SUBJECT:	VARIOUS TRAFFIC REGULATION ORDERS - AMENDMENT ORDER NO. 17 2025
MEETING:	INDIVIDUAL CABINET MEMBER DECISION – COUNCILLOR CATRIN MABY
DATE:	20/08/2025
DIVISION/WARDS AFFECTED:	WYESHAM, LLANTILLIO CROSSENNY, DRYBRIDGE, OVERMONNOW, MITCHELL TROY AND TRELLECH UNITED, RAGLAN, SHIRENEWTON, GOBION FAWR, BULWARK AND THORNWELL, ST ARVANS, DEVAUDEN, PORTSKEWETT, LLANGYBI FAWR.

- 1.1 This report seeks Cabinet Member approval to proceed with the making and implementation of the Monmouthshire County Council Traffic Regulation, Speed Limits and Parking Regulations Consolidation Order 2019 (Amendment Order No. 17) 2025.

Appendix 1: Schedule of Consultation Responses

2216 Redbrook Road, A466, Monmouth Proposed 30mph Speed Limit

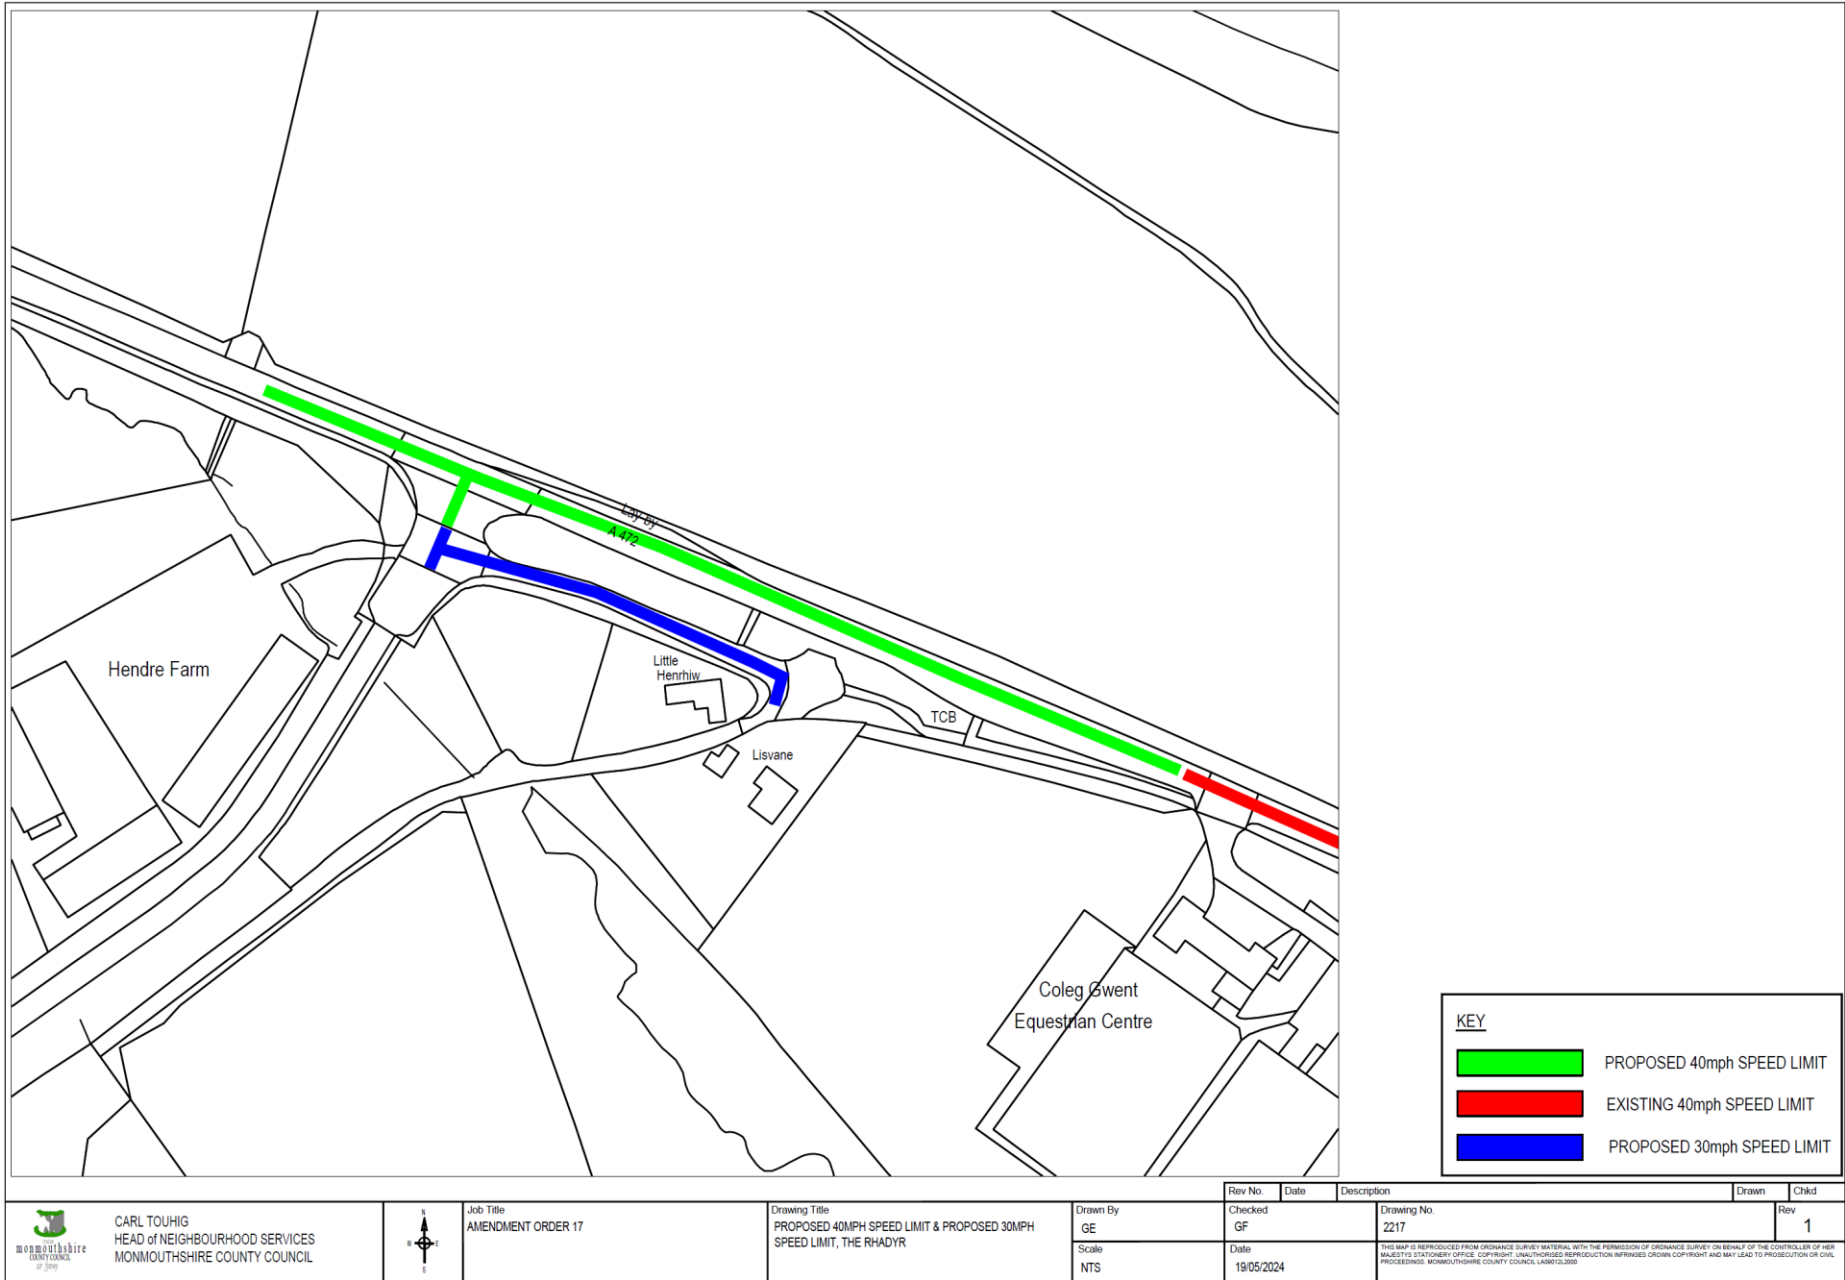
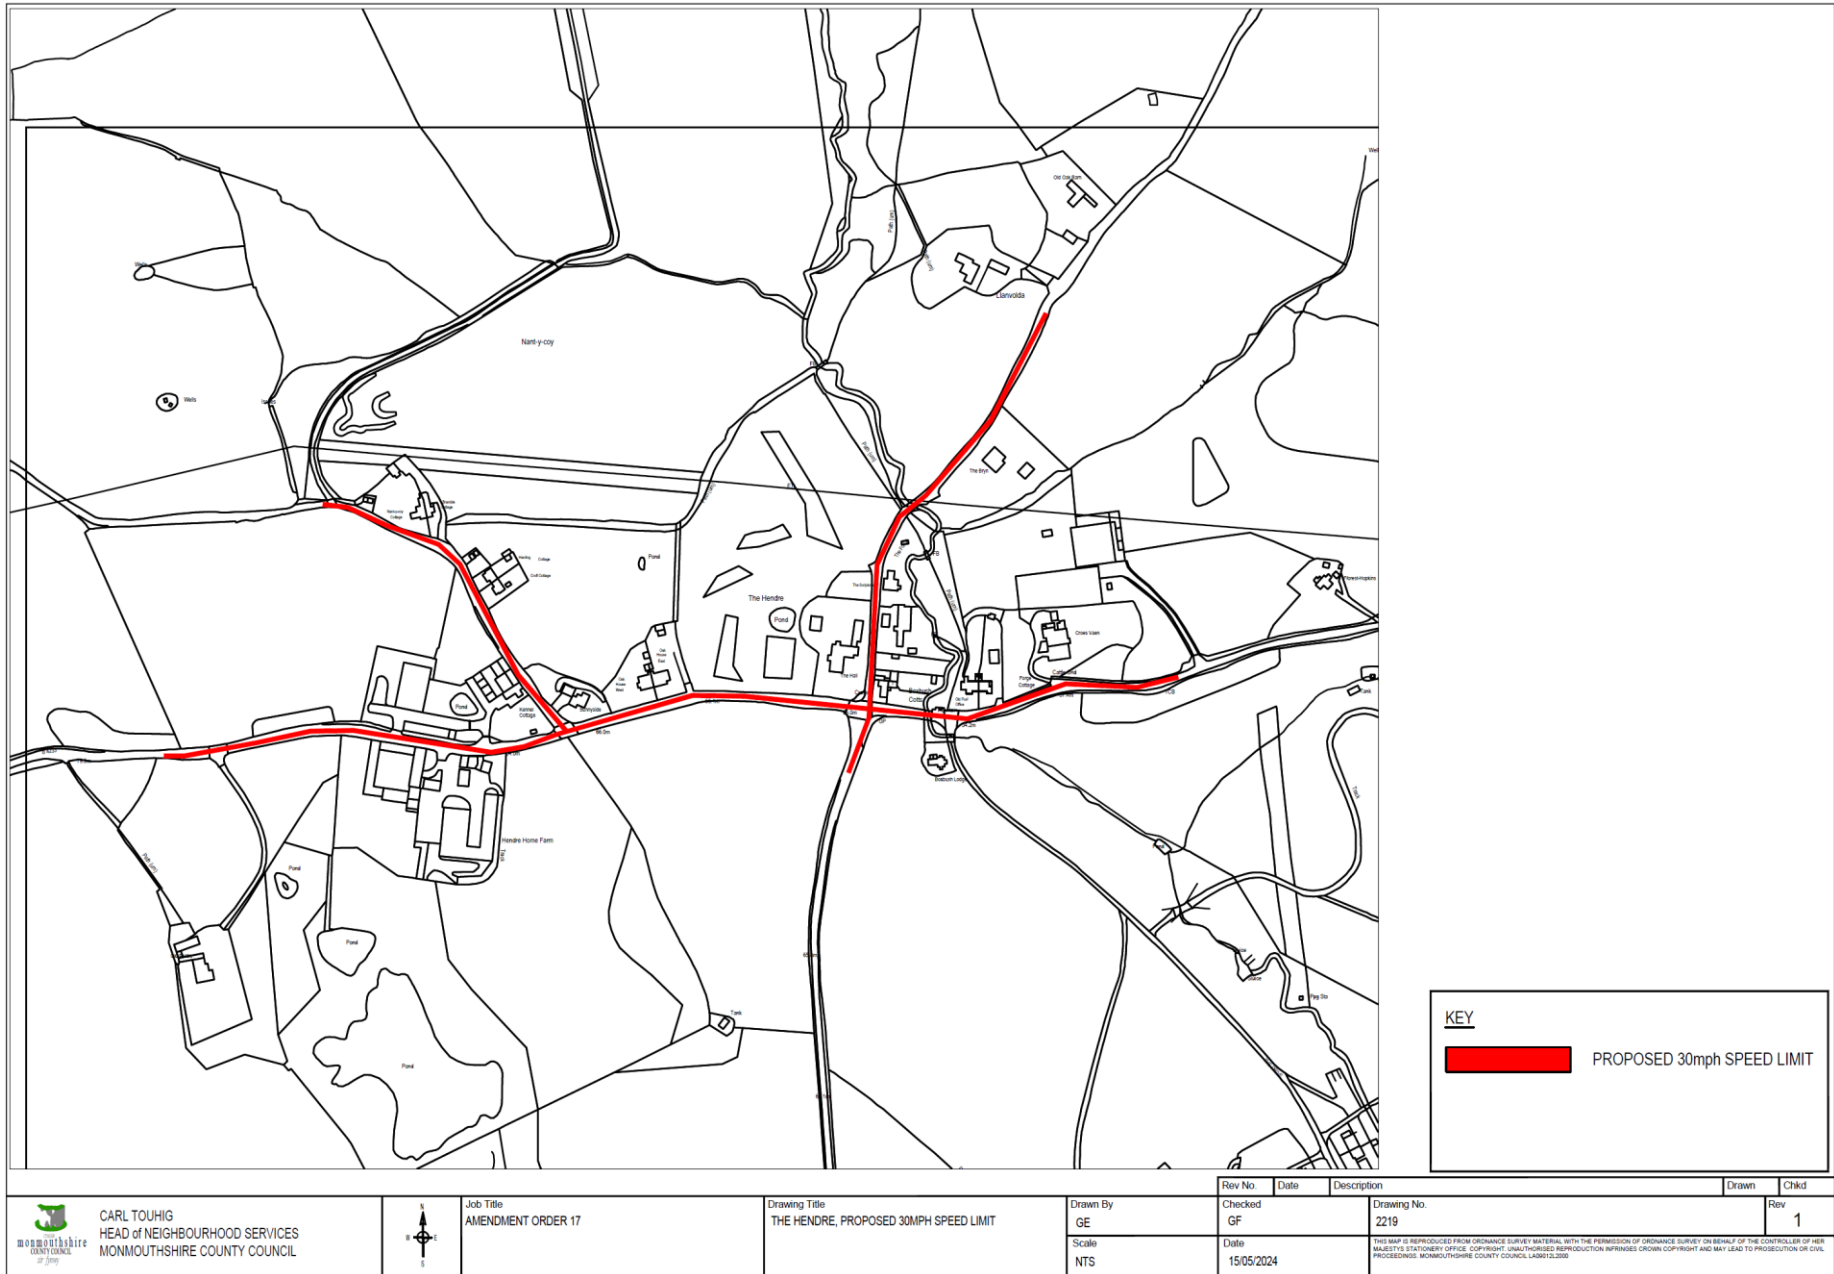
678	No	2216 Redbrook Road, A466, Monmouth - Proposed 30mph Speed Limit (AO17)	This is confusing: The 'reasons' document seems to say that the change is only administrative and the speed limit will stay as it is; but The drawing 2216 shows a red line for the existing limit position and a green line for the intended limit. This drawing therefore suggests that the limit is to be moved, from its current position a hundred or so metres beyond the entrance to Monmouth Showground back, towards the town, ending up on the town side of that the showground entrance. The speed limit was moved to its current position in 2024 following 'Notice of Intention to make a Traffic Order - Amendment Order No 13' (ref: 2121) after representations on behalf of Wyesham residents to improve safety for people walking the footpath from Wyesham Avenue to the Showground. Where the 30MPH speed limit is currently positioned that path is much safer so it makes no sense to move it back towards Monmouth, where it was two years ago. Moreover I am told that the public notice advertising this proposed change has been posted on Staunton Road, nowhere near where the proposed change would take place.	Ref 678 The proposed order for Redbrook Road (2216) is an administrative measure to formalise the existing, signed 30mph speed limit. This action is required to rectify a historical omission that occurred when the wider Monmouth area transitioned to a default 20mph zone, at which time this section was intended to remain at 30mph but was inadvertently excluded from the legal order. The effect of this proposal is to ensure the existing on-street 30mph limit is legally compliant and enforceable. There will be no physical change to the location or extent of the current 30mph speed limit signs on Redbrook Road. The associated technical drawing is a legal document illustrating the section of road that requires this formal order to correct the administrative error. Its purpose is to legally underpin the existing on-street situation. Regarding the public consultation process, a notice for the Redbrook Road proposal was erected in the vicinity of the affected area. The notice observed on Staunton Road related to a different proposal (Order 2225, a 40mph speed limit) which was part of the same county-wide consultation.

679	Somewhat	2216 Redbrook Road, A466, Monmouth - Proposed 30mph Speed Limit (AO17)	I just wish to clarify that the 30mph zone will continue to extend as it currently stands on Redbrook Rd and not revert back to where the zone ended previously. A great many people already break the speed limit in this location but a number do not, and I am hopeful that this number will increase with time. When drivers travel at 30mph along this stretch it makes crossing the road to the showground, walking along the narrow footway to the showground and exiting Wyesham Avenue and the Showground entrance on foot, bike, mobility scooter or motor vehicle a much safer endeavour. It's therefore imperative that the 30 mph zone remains extended to beyond the Showground entrance. Diolch	Ref 679 Your comments are noted. This proposal is to formalise the existing, signed 30mph speed limit to rectify a historical administrative omission. There will be no change to the extent of the 30mph speed limit currently signed on the ground.

2217 A472, The Rhadyr, Usk Proposed 40mph and 30mph Speed Limit

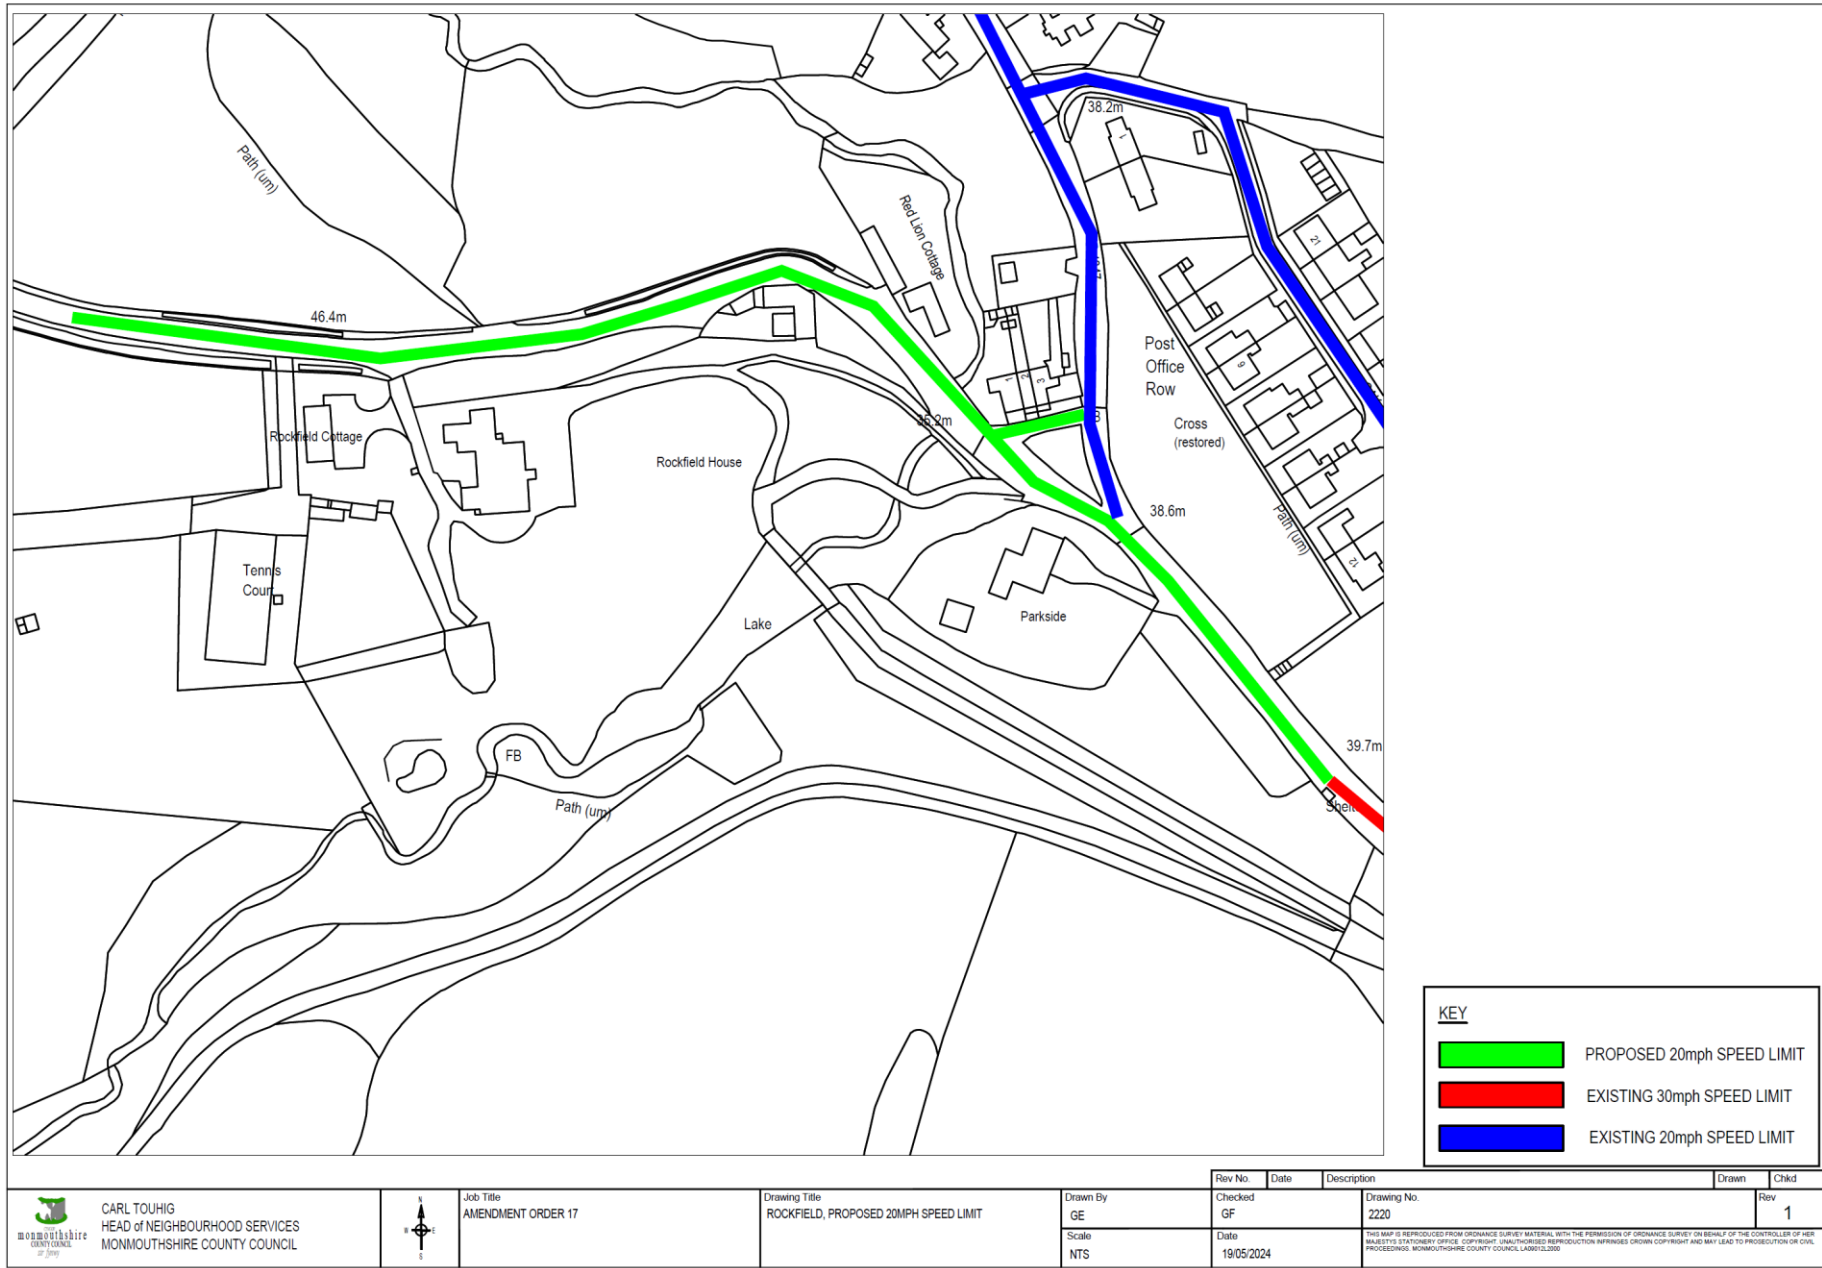
710	Yes	2217 A472, The Rhadyr, Usk - Proposed 40mph and 30mph Speed Limit (AO17)	As Site Manager of BAE Systems Glascoed we are very much in favour of a reduction in speed along this stretch of the road, would also welcome it being extended past our west access as well.	Ref 710 Your support for this proposal is noted.
711	Somewhat	2219 B4233, The Hendre - Proposed 30mph Speed Limit (AO17)	Currently the limit in the areas shown on map 2219 are set at 40mph and I do not think there is any great problem with traffic exceeding that speed but have no real objection to reducing that limit to 30mph as traffic (except for the B4233) rarely exceeds that. However 30mph limit on the B4233 would potentially improve safety at the junction just east of Home Farm as this is approached blind for traffic coming from Abergavenny direction and a reduced limit would reduce the risk to those pulling out onto the B4233. Also the bend in front of the entrance to the Rolls of Monmouth Gold course may also benefit from a 30mph limit.	Ref 711 Your support for this proposal is noted. The start and end points of the proposed 30mph zone were determined during a traffic engineering assessment to encompass the main residential area and its associated access points. If necessary, the extents of the speed limit will be reviewed at a later date.
